BALTIMORE COUNTY PUBLIC SCHOOLS

ADDENDUM NUMBER _1_

BID NAME: NEW SCHOOL CONSTRUCTION LANSDOWNE ELEMENTARY
SCHOOL/DEMOLITION OF LANSDOWNE ELEMENTARY
SCHOOL__

BID NUMBER: **MBU-516-17**

SK- C -1

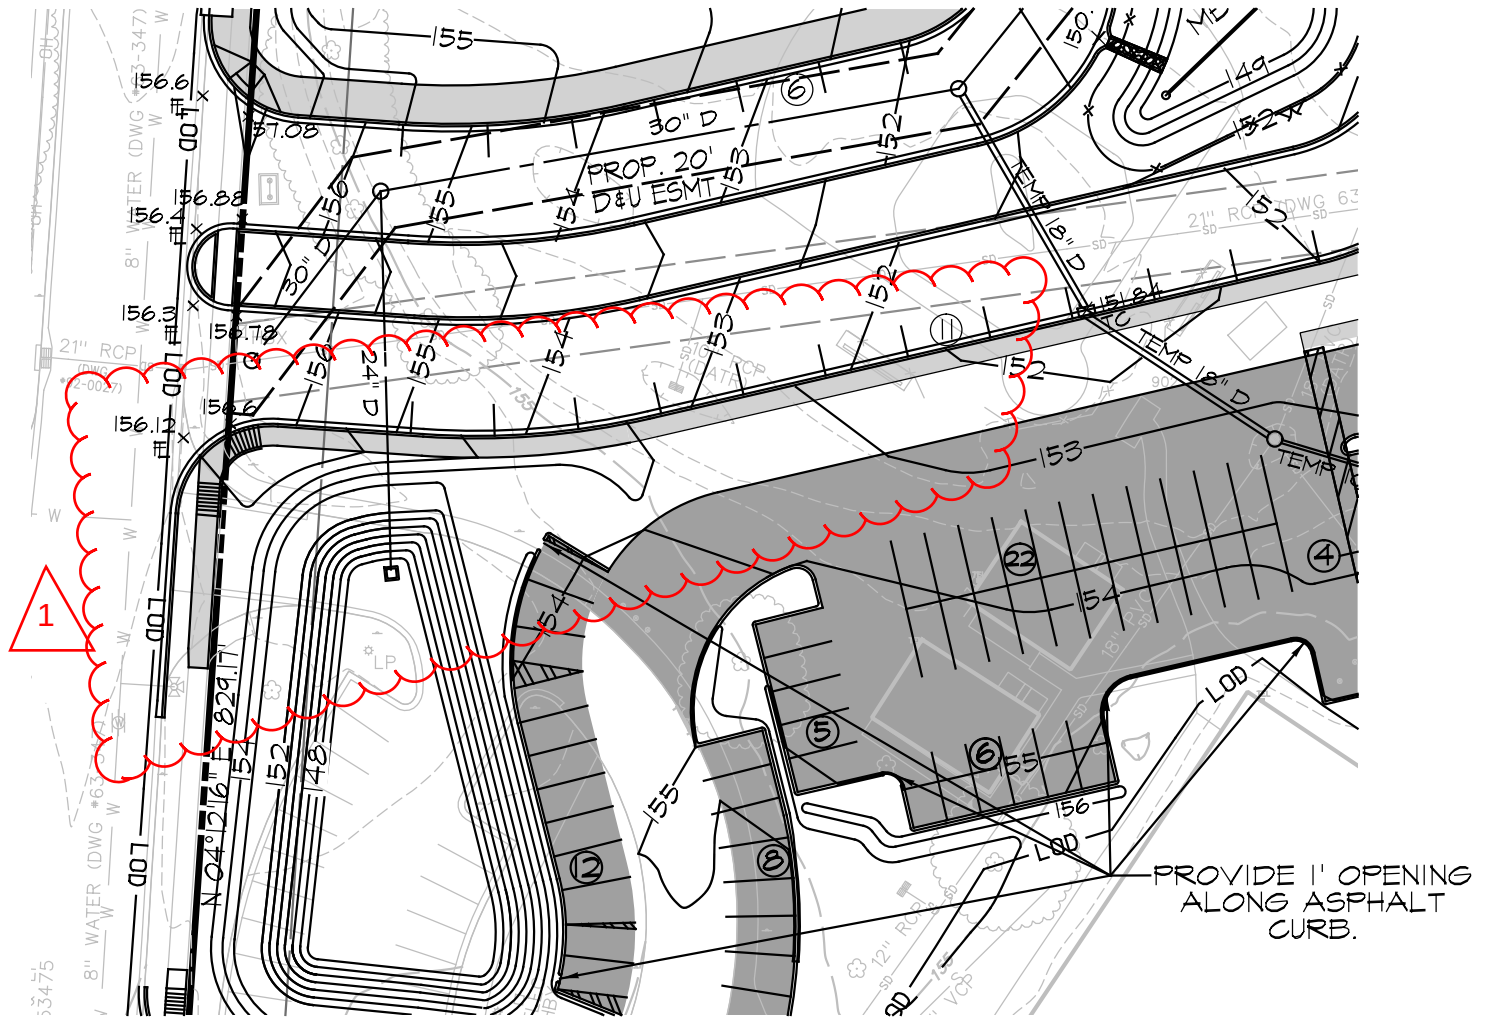
- 3.1. SHEET C-0.3B, EXISTING CONDITIONS/DEMOLITION PLAN - PHASE 2
REVISE: Demolition Note 4 to "Existing Manhole to be Removed".
- 3.2. SHEET C-0.4A, PHASING PLAN-PHASE 1
ADD: Sidewalk connection between Alma Road and Proposed Lansdowne Elementary School as indicated in attached sketch SK-C-1.
- 3.3. SHEET C-0.4B, PHASING PLAN-PHASE 2
ADD: Sidewalk connection between Alma Road and Proposed Lansdowne Elementary School as indicated in attached sketch SK-C-2 & C-2A.
- 3.4. SHEET C-1.1, SITE AND GRADING PLAN-PHASE 1
ADD: Sidewalk connection between Alma Road and Proposed Lansdowne Elementary School as indicated in attached sketch SK-C-3.

SK- C -3A

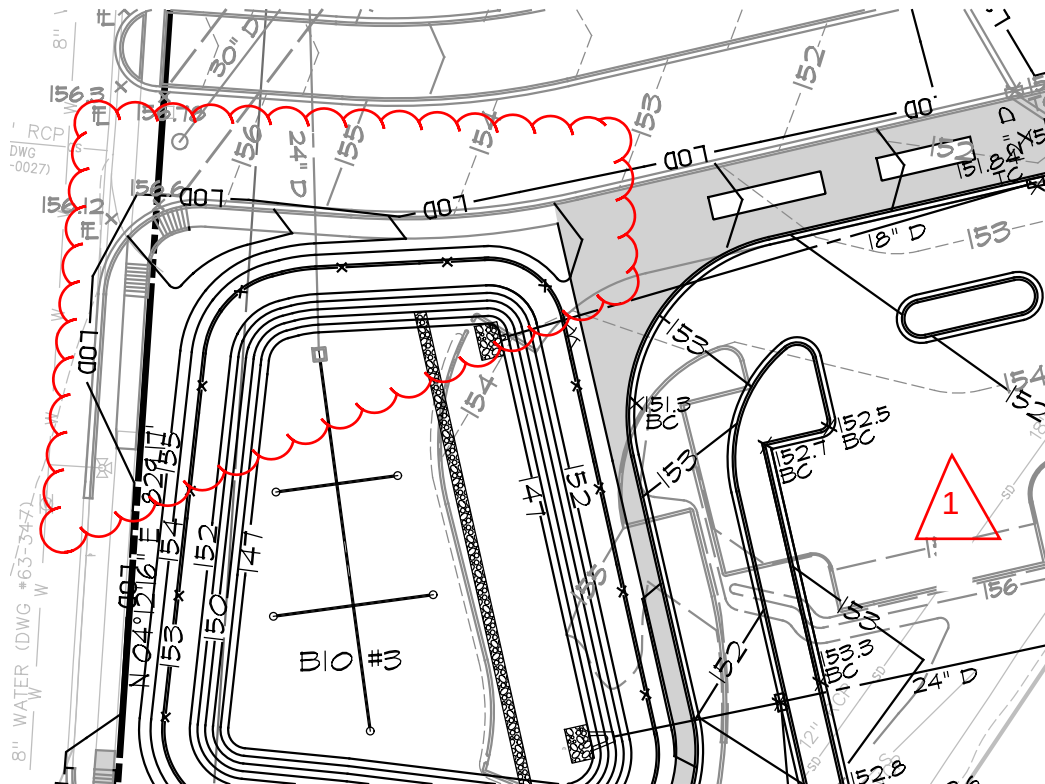
REVISE: Revised notes as indicated in attached sketch SK-C-3A.
- 3.5. SHEET C-1.2, SITE AND GRADING PLAN-PHASE 2
ADD: Sidewalk connection between Alma Road and Proposed Lansdowne Elementary School as indicated in attached sketch SK-C-4.
- 3.6. SHEET C-1.5, SITE DETAILS
REVISE: Detail 12 – Ex. Inlet to be slabbed over. Include vertical dowel as indicated in attached sketch SK-C-5.
- 3.7. SHEET C-3.1, GEOMETRY PLAN-PHASE 1
ADD: Sidewalk connection between Alma Road and Proposed Lansdowne Elementary School as indicated in attached sketch SK-C-6.

SK- C -5

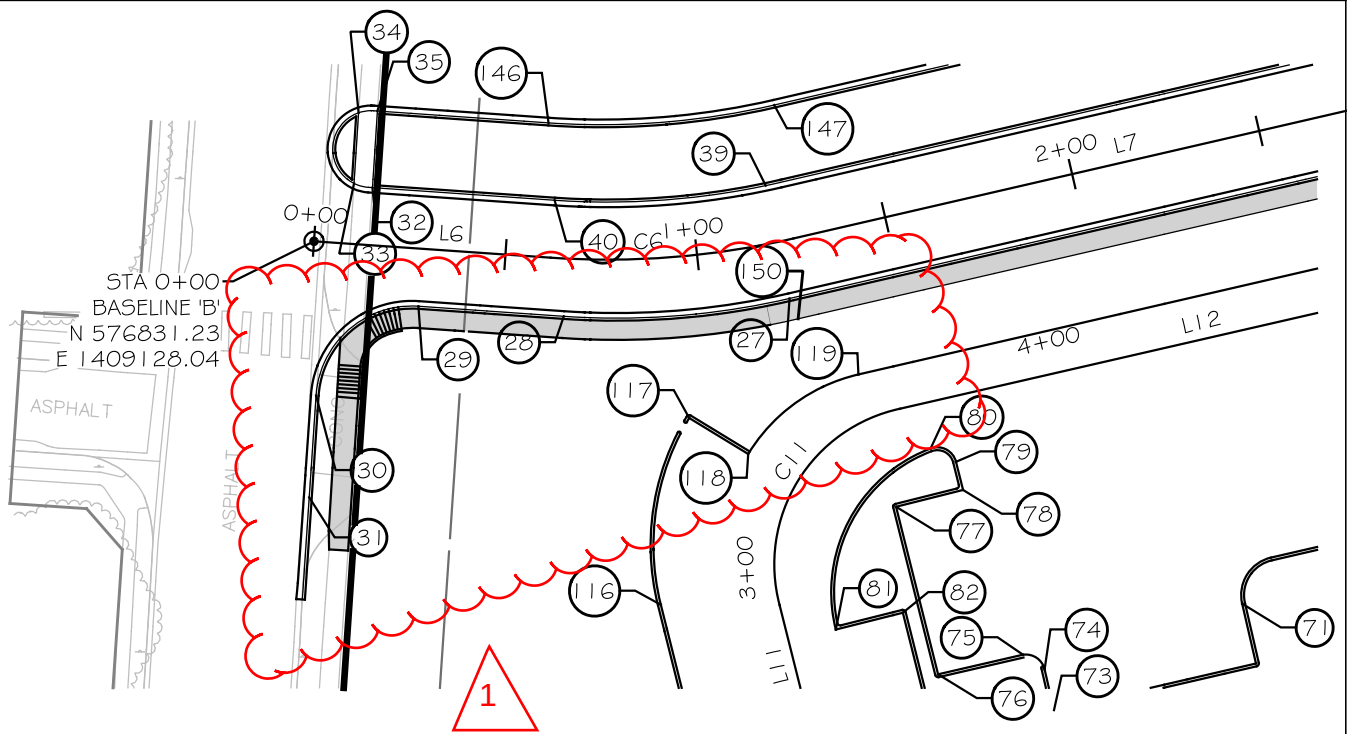
12 EX. INLET TO BE SLABBED OVER

SK- C -8

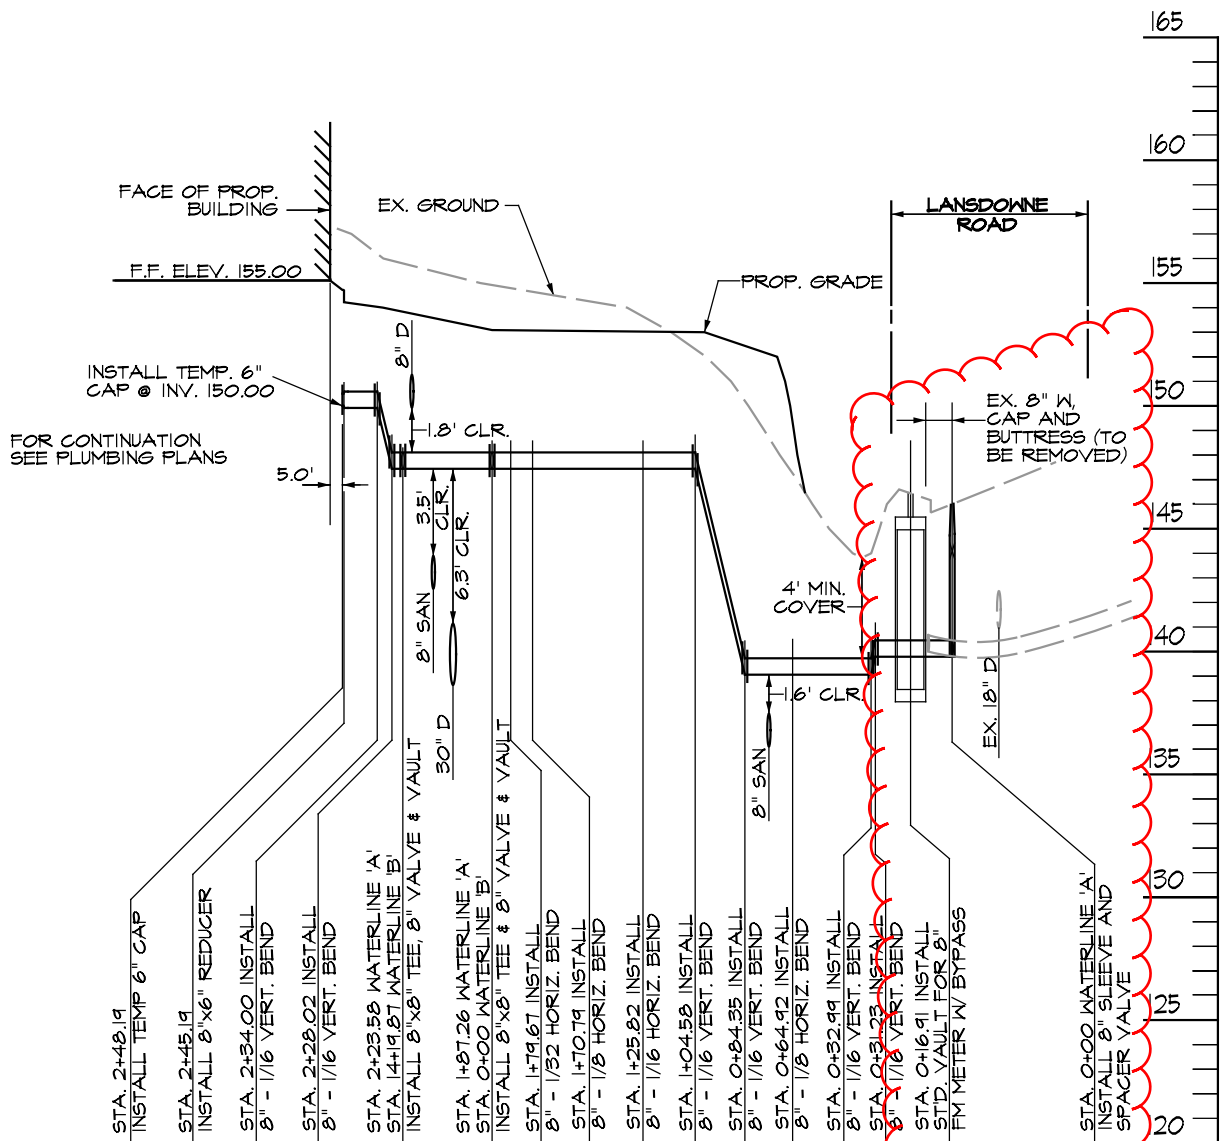
REVISE: Dimension callout to the northeast corner of the Proposed Lansdowne Elementary School to 159.45'.
- 3.8. SHEET C-3.2, GEOMETRY PLAN-PHASE 2
REVISE: Dimension callout to the northeast corner of the Proposed Lansdowne Elementary School to 159.45'.
- 3.9. SHEET C-4.1, UTILITY PLAN
REVISE: Storm Drain Structure Schedule as indicated in attached sketch SK-C-8.

SK-C-9

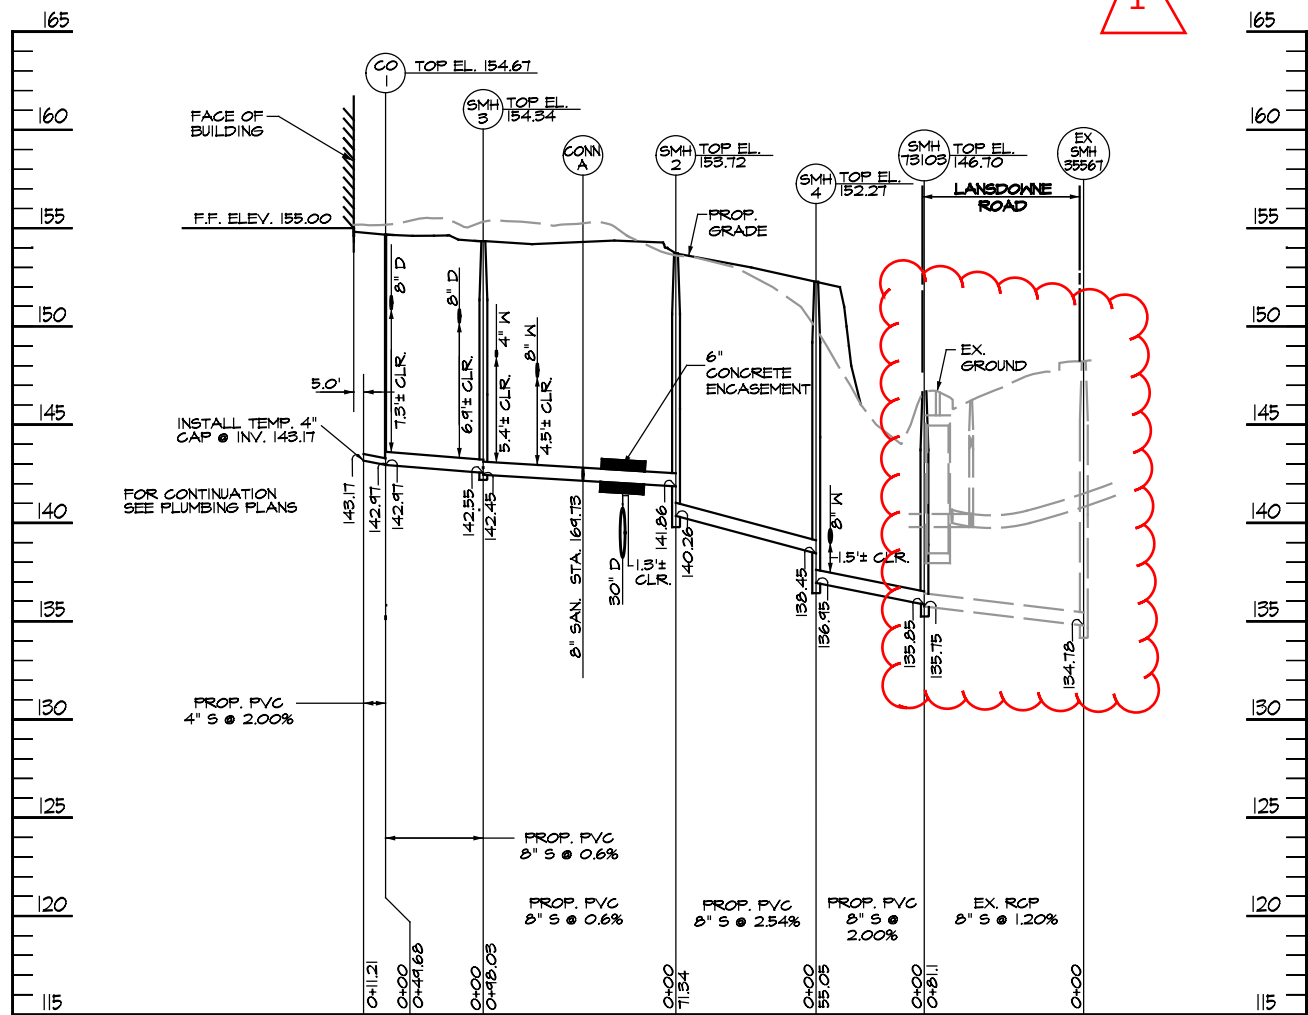
- 3.10. SHEET C-4.2, UTILITY PROFILES
REVISE: 8" Waterline 'A' Profile as indicated in attached sketch SK-C-9.
- 3.11. SHEET C-4.3, UTILITY PROFILES
REVISE: 8" Sanitary Sewer Profile as indicated in attached sketch SK-C-10.
